**PLANNING APPROVAL
STAFF REPORT****Date: December 16, 2010**

<u>NAME</u>	Mobile Terrace Christian Center Subdivision
<u>SUBDIVISION NAME</u>	Mobile Terrace Christian Center Subdivision
<u>LOCATION</u>	7154 Ninth Street (North side of Ninth Street, 200'± East of Lincoln Boulevard)
<u>CITY COUNCIL DISTRICT</u>	District 7
<u>PRESENT ZONING</u>	R-1, Single-Family Residence District
<u>AREA OF PROPERTY</u>	1 lot / 0.11 acres ±
<u>CONTEMPLATED USE</u>	Planning Approval to allow a church facility in an R-1, Single-Family Residential District, and Subdivision approval to create one legal lot.
<u>TIME SCHEDULE FOR DEVELOPMENT</u>	Immediate
<u>ENGINEERING COMMENTS</u>	Must comply with all storm water and flood control ordinances. Detention must be provided for all impervious area(s) added to the site in excess of 4,000 square feet. Any work performed in the right of way will require a right of way permit in addition to any required land disturbance permit. Drainage from any new dumpster pads cannot discharge to storm sewer; must have connection to sanitary sewer. Driveway radii shall not extend beyond the projected property line at the edge of pavement, without written authorization from a

DETAIL SITE PLAN

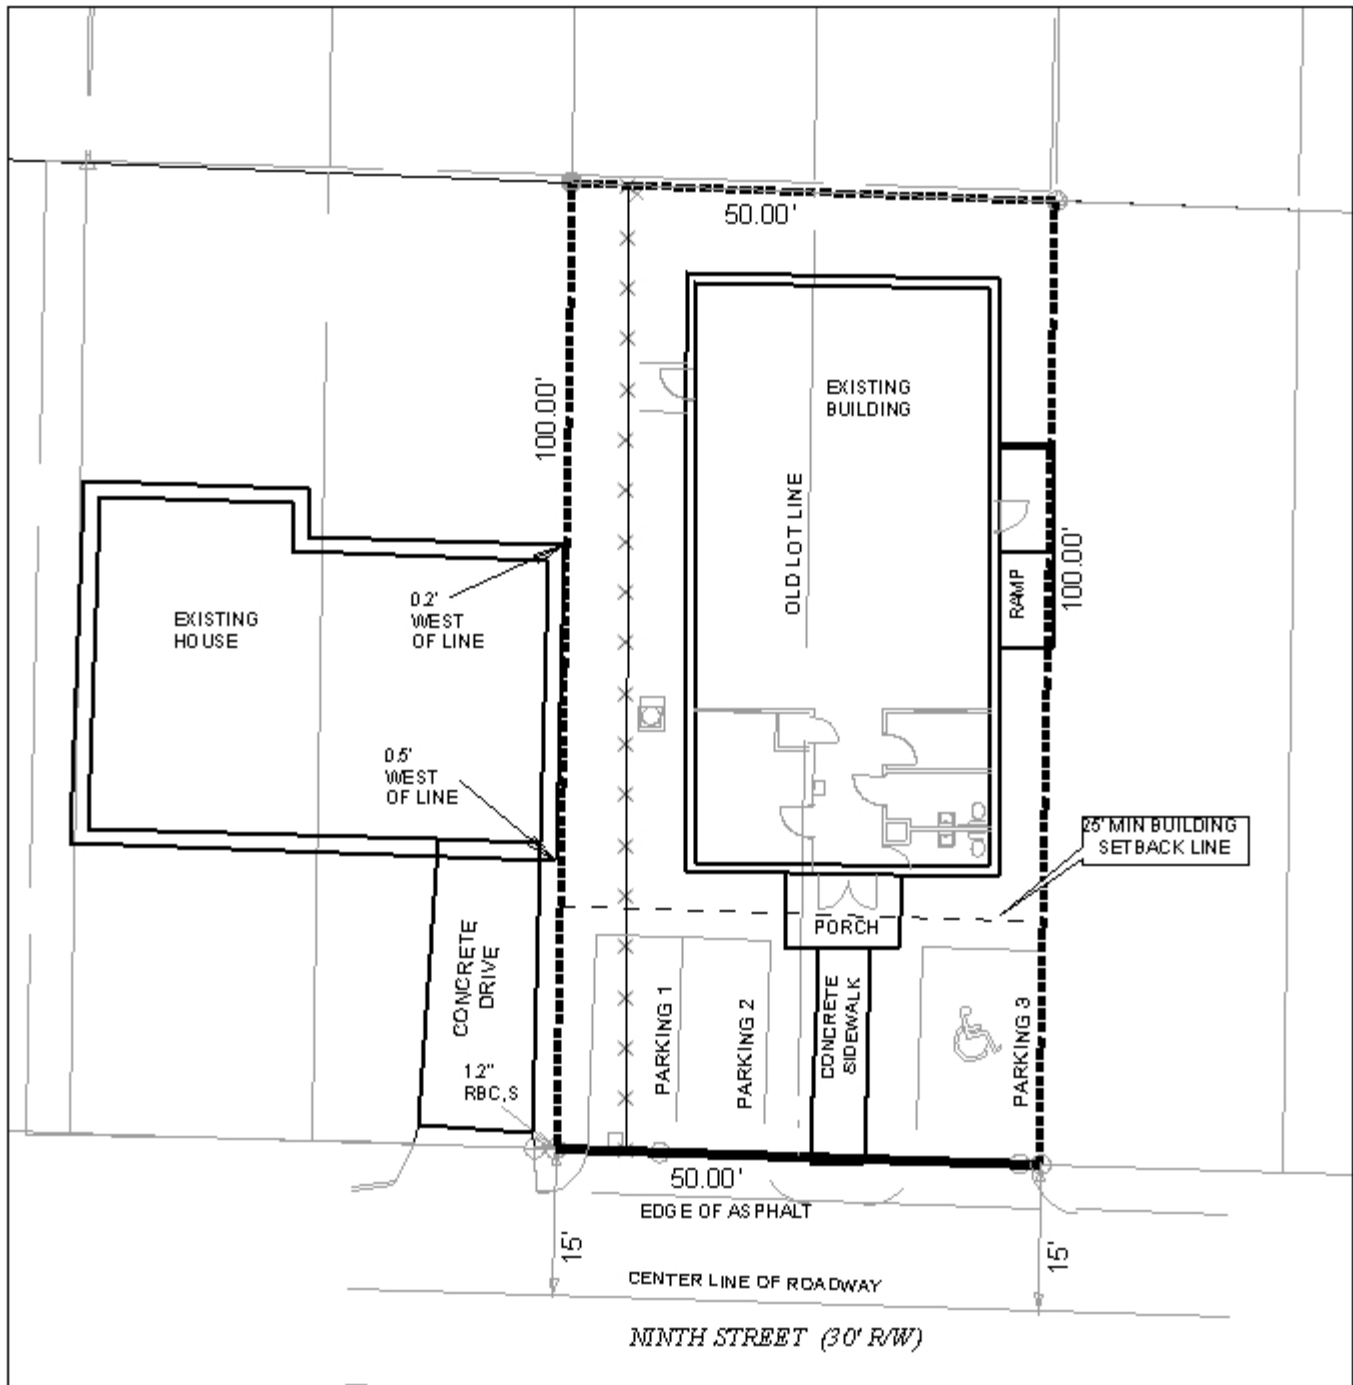
It should be pointed out that the limited right-of-way width may prohibit the provision of a sidewalk in front of the building. No sidewalk is shown on the site plan, and there are no

sidewalks in the vicinity, however, the applicant has not applied for a sidewalk waiver, and the Subdivision Regulations do require the provision of a sidewalk.

With the completed porch improvements, the total site coverage of the building will be 41.7%, which is above the 35% allowed within R-1 districts. A variance for site coverage should be required, if the Planning Approval is approved. Furthermore, the structure encroaches into front and side yard setbacks, thus variances are needed for those encroachments. Finally, it appears that a ramp on the East side of structure actually crosses a property line, encroaching onto property not owned by the applicant.

No information is provided regarding tree and landscape compliance. If the site does not meet the minimum requirements of the Zoning Ordinance, variances will be required. Also, no fence or other buffers are depicted, and such buffers are typically required when a non-residential use is allowed within a residential district.

The proposed parking area will require that vehicles back into the right-of-way, which is prohibited by Section 64-6.A.2. of the Zoning Ordinance except for single family and duplex uses. Therefore a variance will also be required for the proposed back-out parking.

There is no indication on the site plan as to how waste from the proposed youth center will be removed. If a dumpster will be used, it must be shown on the site plan, or a note must be placed on the plan indicating how waste will be removed from the site.

The site is currently unbuffered where it abuts residences to the North and the West. A six-foot high wooden privacy fence should be required on the North and West sides, except within the 25-foot setback, where the fence shall not exceed 3-feet in height.

Regarding tree and landscaping compliance, the applicant must provide 1 frontage tree, 4 perimeter trees, 1 parking tree, and a minimum of 600 square feet of total landscape area, of which at least 360 square feet must be between the building and the street.

It is assumed that waste will be generated by the proposed youth facility. The applicant should indicate if waste removal will be via a public or private service, and if a dumpster or curb-side containers will be used.

- 1) Revision of the plat to depict the minimum setback line to allow for future dedication to provide 25-feet from the centerline of Ninth Street;
- 2) Placement of a note on the final plat stating that the lot is limited to one curb-cut, with the size, design and location to be approved by Traffic Engineering and to conform to AASHTO standards;

- 1) The use is not in harmony with the residential nature of the area, due to potential noise, congregation and hours of operation issues;*
- 2) The use and associated parking will create congestion along a substandard street; and*
- 3) The location of a youth facility on a street lacking sidewalks will generate hazards for children as they walk in the streets to and from the facility.*
